**Center for Advanced
Aviation System Development**

Nuevo Aeropuerto Internacional de la Ciudad de México Preliminary Airspace Redesign

Informal Working Notes on Departure Procedures

30 June 2016

Figure A-25. NAICM RNAV SID: Runway 3 Land North (NAICM_SID_SW_Land_North_R3_A45)

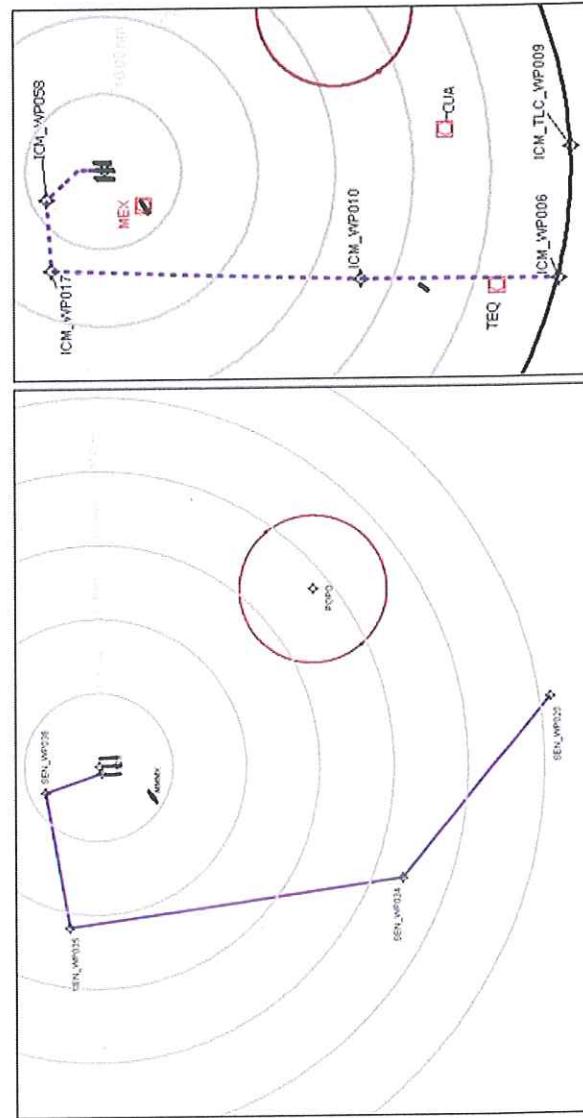
SENEAM and MITRE agreed to create two exit fixes on the southern TMA boundary at a 60 NM range from the NAICM reference point provided by SENEAM. The graphic on the right displays the location of both fixes and their relative position to each other. The departure initially diverges 45 degrees from runway heading. At waypoint ICM_WP017, the departures are deconflicted from the NAICM downwind traffic and can then climb unrestricted. At waypoint ICM_WP010, the aircraft will be above the NAICM arrival traffic from the southwest. This is an alternate design that is offset by 45 degrees from a straight out departure instead of the 30 degree divergence in the original SID NAICM_SID_SW_Land_North_R3, shown in Figure A-24.

Figure A-26. NAICM RNAV SID: Runway 3 Land North (NAICM_SID_W_Land_North_R3)

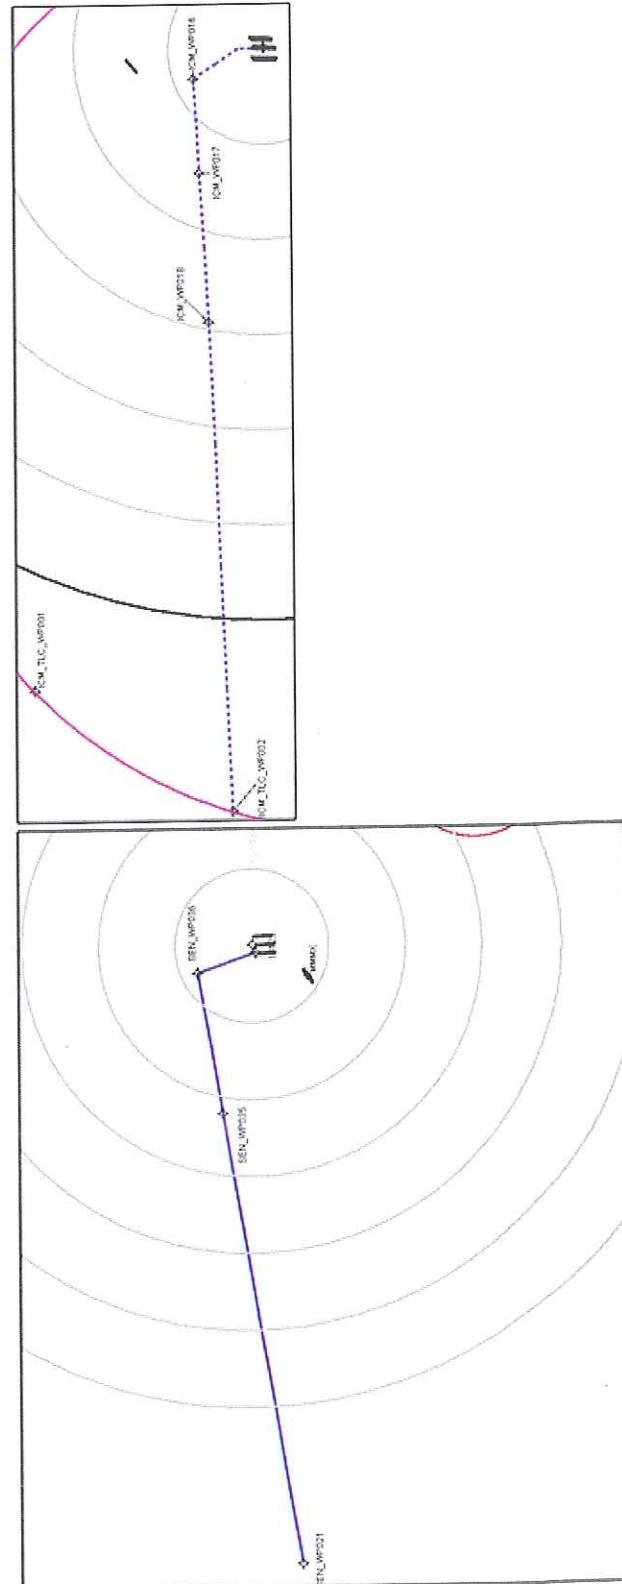
SENEAM and MITRE agreed to create two exit fixes on the western TMA boundary. Both fixes are located at a 50 NM range from the Toluca VOR (TLC). The graphic on the right displays the location of both fixes and their relative position to each other. The departure initially diverges from runway heading 30 degrees. At waypoint ICM_WP017, the departures are deconflicted from the NAICM downwind traffic and can then climb unrestricted.

Figure A-27. NAICM RNAV SID: Runway 3 Land North (NAICM_SID_W_Land_North_R3_A45)

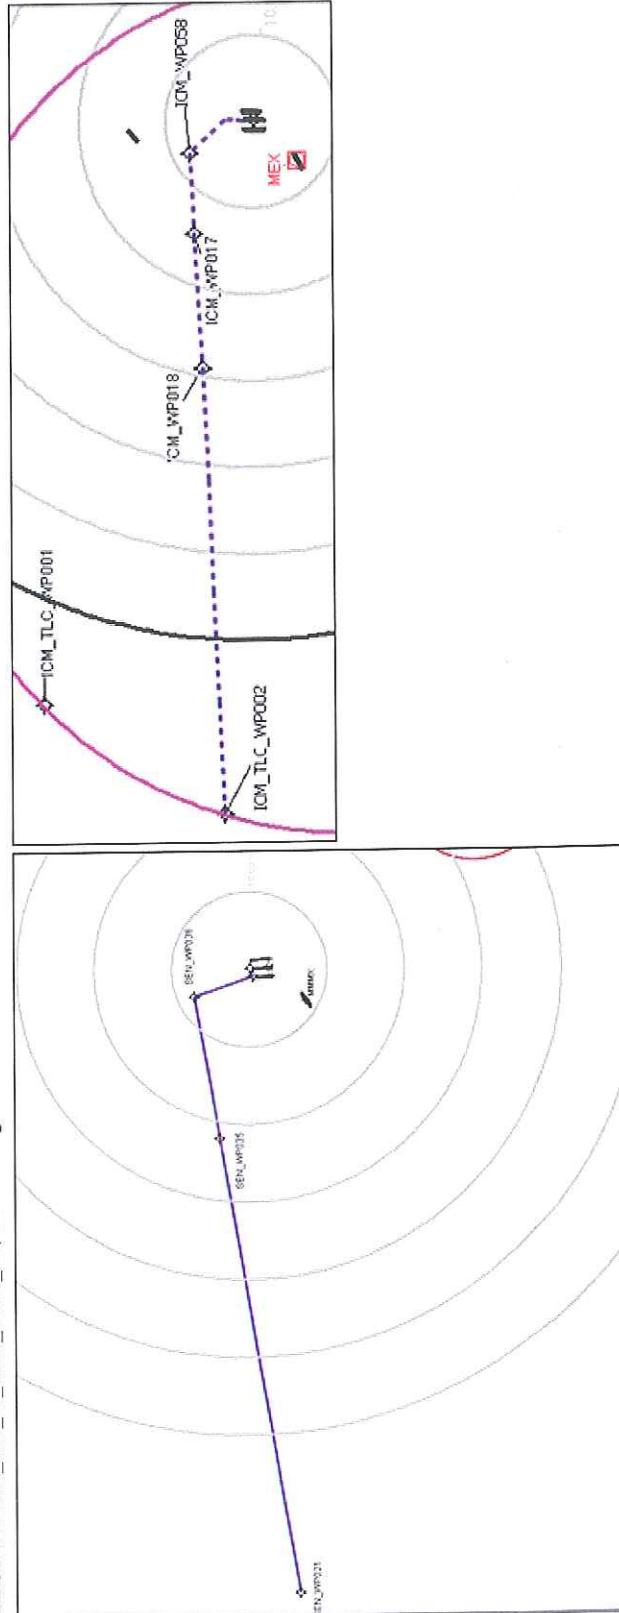
SENEAM and MITRE agreed to create two exit fixes on the western TMA boundary. Both fixes are located at a 50 NM range from the Toluca VOR (TLC). The graphic on the right displays the location of both fixes and their relative position to each other. The departure initially diverges from runway heading 45 degrees. At waypoint ICM_WP017, the departures are deconflicted from the NAICM downwind traffic and can then climb unrestricted. This is an alternate design that is offset by 45 degrees from a straight out departure instead of the 30 degree divergence in the original SID NAICM_SID_W_Land_North_R3, shown in Figure A-26.

Figure A-28. NAICM RNAV SID: Runway 3 Land North (NAICM_SID_WN_Land_North_R3)

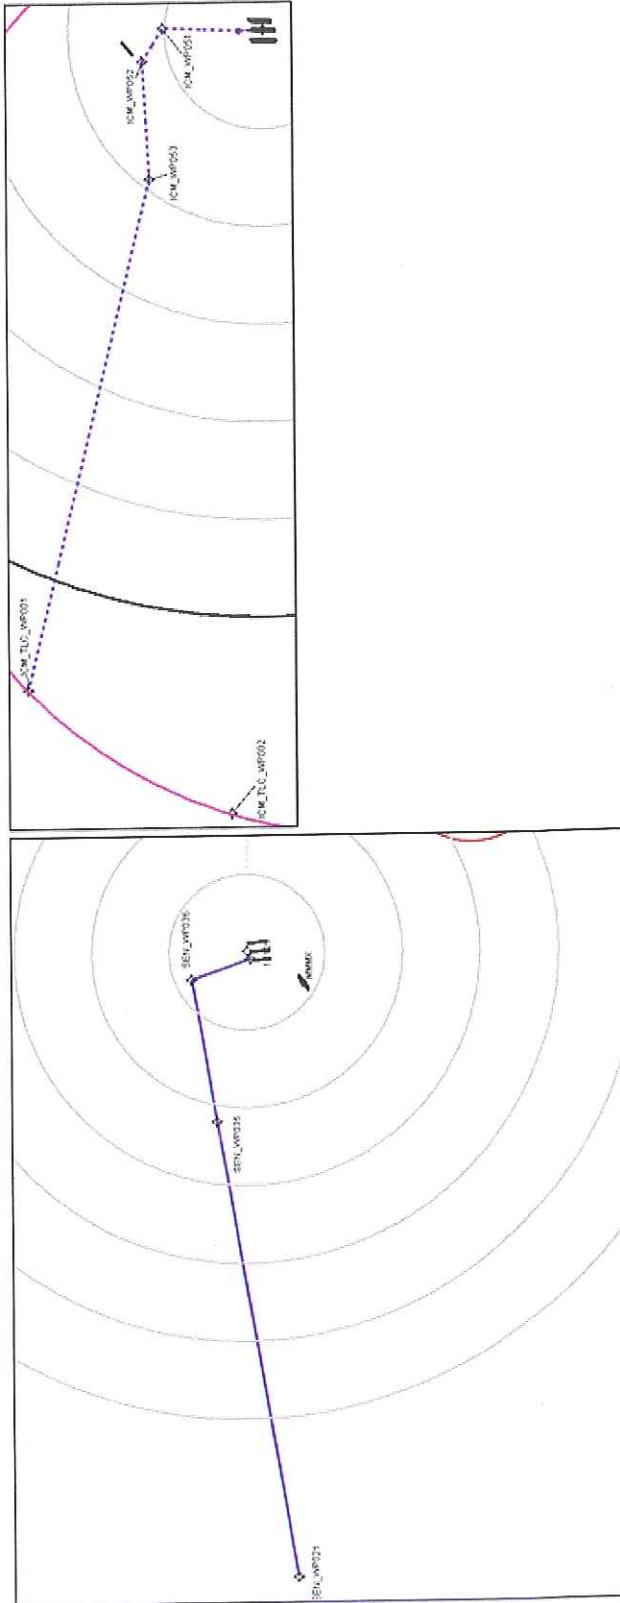
SENEAM and MITRE agreed to create two exit fixes on the western TMA boundary. Both fixes are located at a 50 NM range from the Toluca VOR (TLC). The graphic on the right displays the location of both fixes and their relative position to each other. The departure initially proceeds on runway heading and then remains laterally deconflicted from the west and southbound departures from Runway 2. At waypoint ICM_WP053, the departures are deconflicted from the NAICM arrivals and can climb unrestricted.

Figure A-29. NAICM RNAV SID: Runway 3 Land North (NAICM_SID_NW_Land_North_R3)

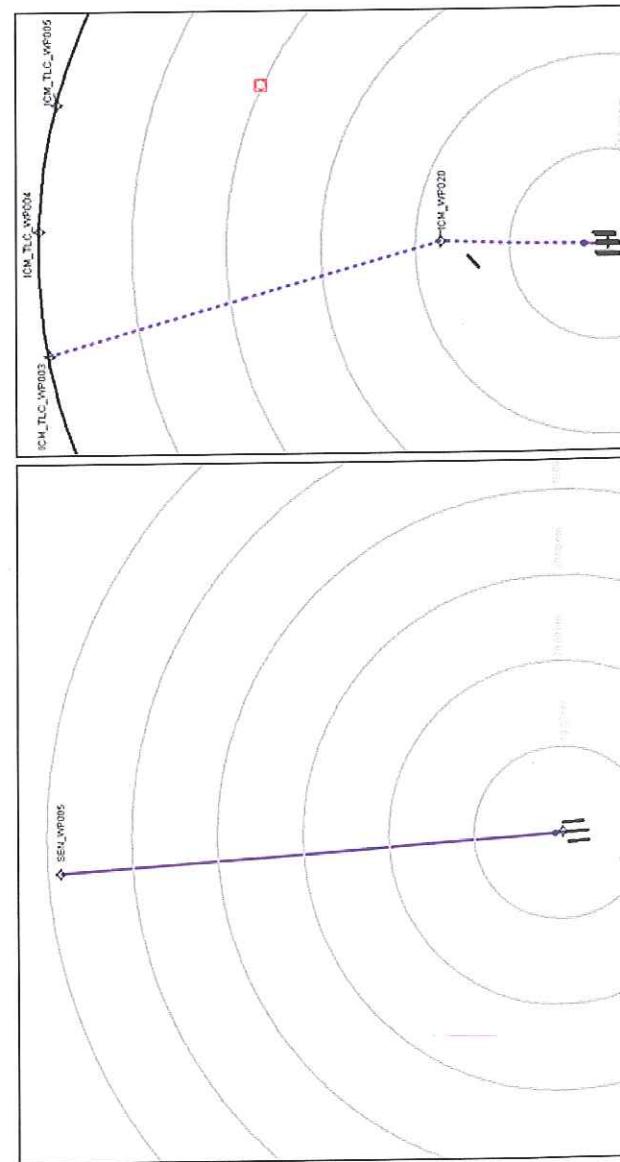
SENEAM and MITRE agreed to create three exit fixes on the northern TMA boundary at a 60 NM range from the NAICM reference point provided by SENEAM. The graphic on the right displays the location of all three fixes and their relative position to each other. The departure initially proceeds on runway heading which diverges 30 degrees from departures on Runways 2 and 6 in most scenarios.

Figure A-30. NAICM RNAV SID: Runway 3 Land North (NAICM_SID_N_Land_North_R3)

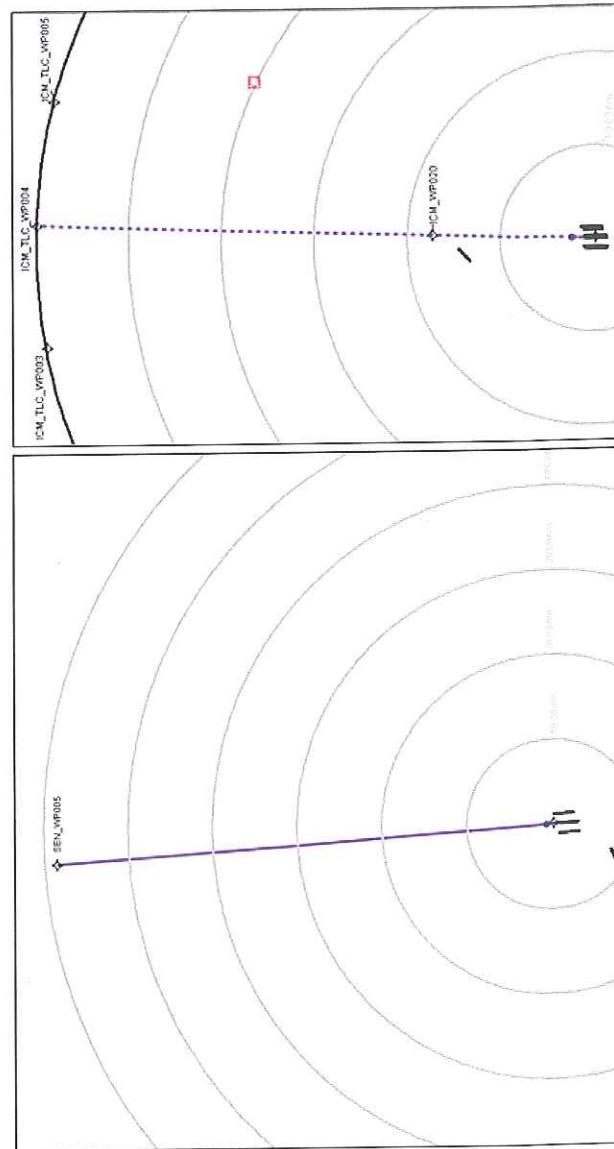
SENEAM and MITRE agreed to create three exit fixes on the northern TMA boundary at a 60 NM range from the NAICM reference point provided by SENEAM. The graphic on the right displays the location of all three fixes and their relative position to each other. The departure initially proceeds on runway heading which diverges 30 degrees from departures on Runways 2 and 6 in most scenarios.

Figure A-31. NAICM RNAV SID: Runway 3 Land North (NAICM_SID_NE_Land_North_R3)

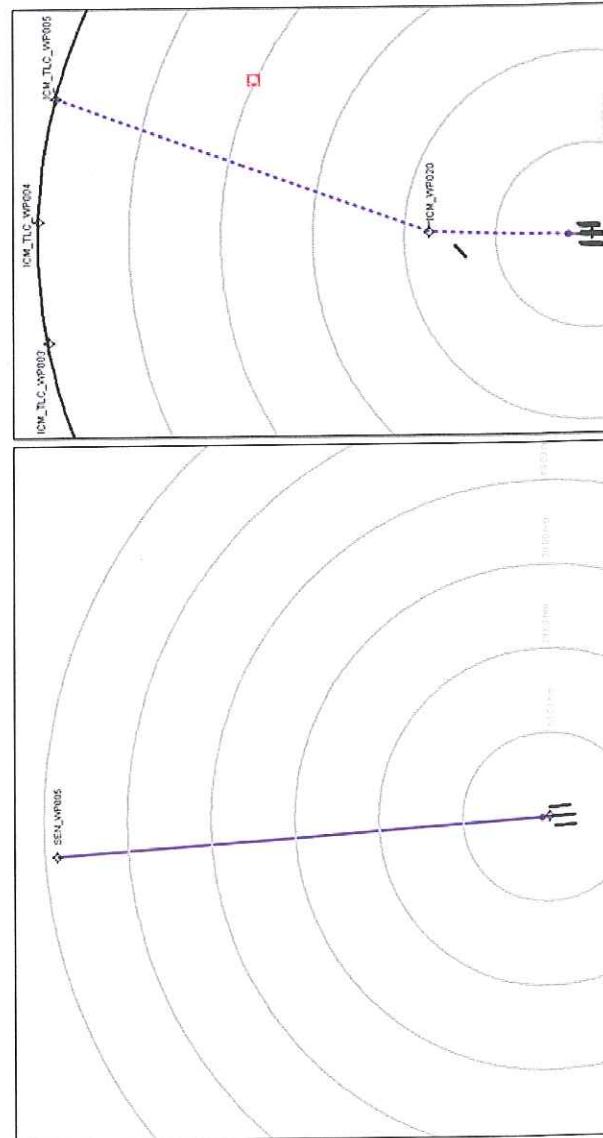
SENEAM and MITRE agreed to create three exit fixes on the northern TMA boundary at a 60 NM range from the NAICM reference point provided by SENEAM. The graphic on the right displays the location of all three fixes and their relative position to each other. The departure initially proceeds on runway heading which diverges 30 degrees from departures on Runways 2 and 6 in most scenarios.

Figure A-32. NAICM RNAV SID: Runway 6 Land North (NAICM_SID_EN_Land_North_R6)

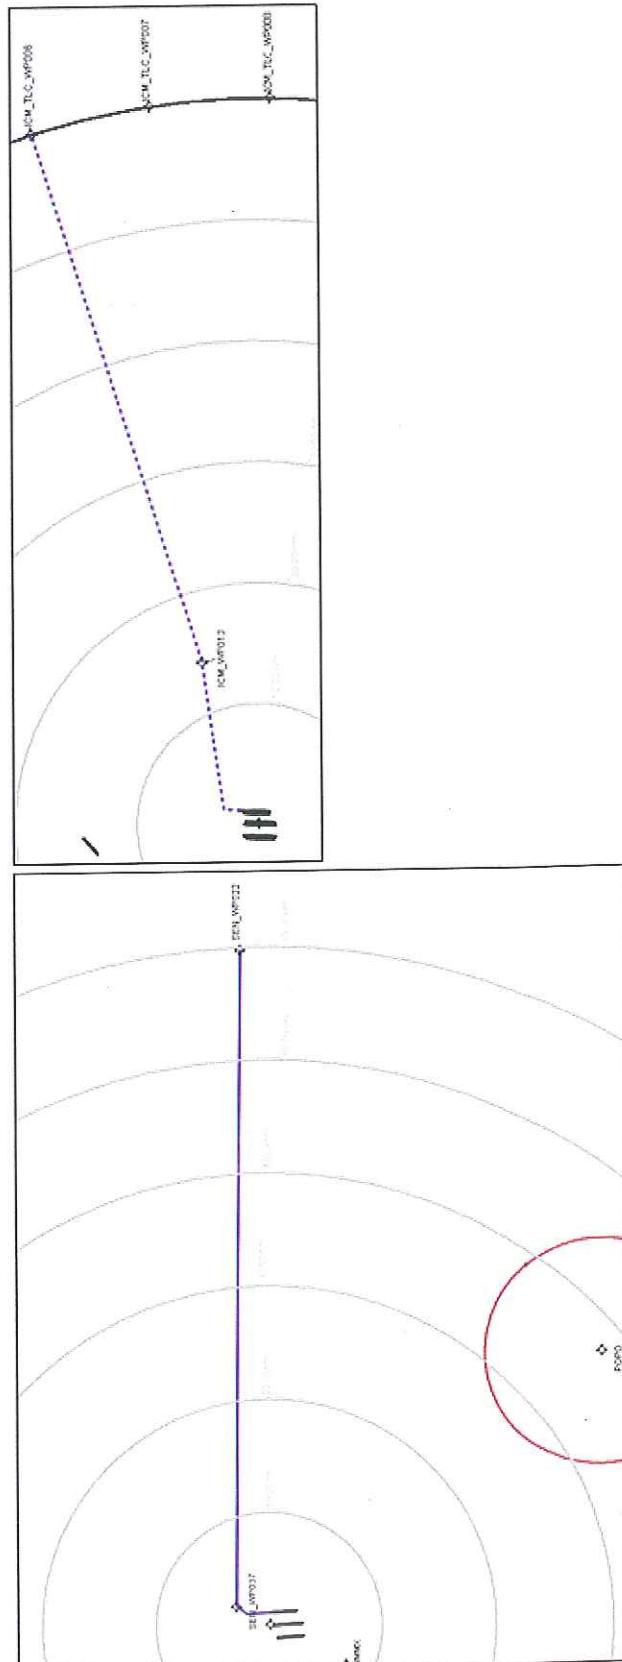
The decision was made to create three exit fixes on the eastern TMA boundary at a 60 NM range from the NAICM reference point provided by SENEAM. The graphic on the right displays the location of all three fixes and their relative position to each other. The waypoint ICM_WP013 was added to restrict departures below the NAICM arrivals on downwind.

Figure A-33. NAICM RNAV SID: Runway 6 Land North (NAICM_SID_E_Land_North_R6)

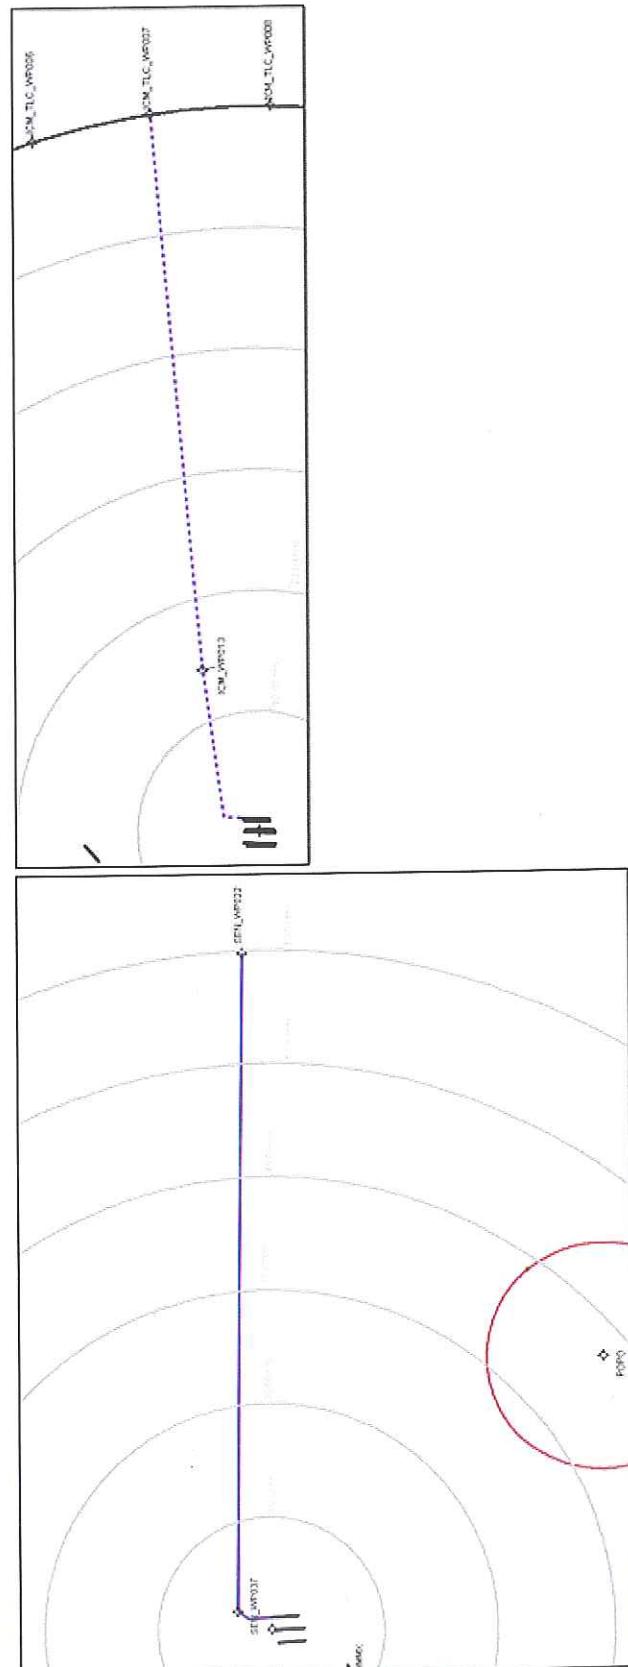
SENEAM and MITRE agreed to create three exit fixes on the eastern TMA boundary at a 60 NM range from the NAICM reference point provided by SENEAM. The graphic on the right displays the location of all three fix and their relative position to each other. The waypoint ICM_WP013 was added to restrict departures below the NAICM arrivals on downwind.

Figure A-34. NAICM RNAV SID: Runway 6 Land North (NAICM_SID_ES_Land_North_R6)

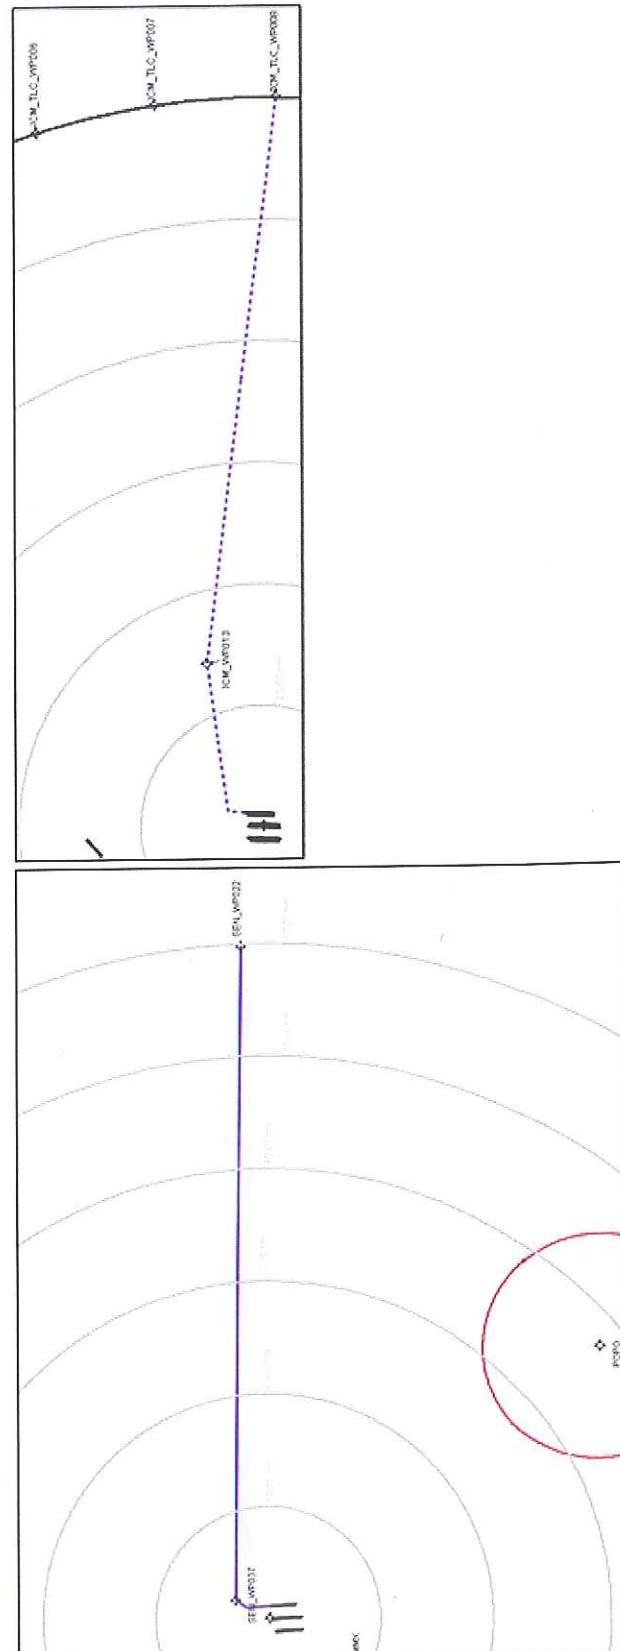
SENEAM and MITRE agreed to create three exit fixes on the eastern TMA boundary at a 60 NM range from the NAICM reference point provided by SENEAM. The graphic on the right displays the location of all three points and their relative position to each other. The waypoint ICM_WP013 was added to restrict departures below the NAICM arrivals on downwind.
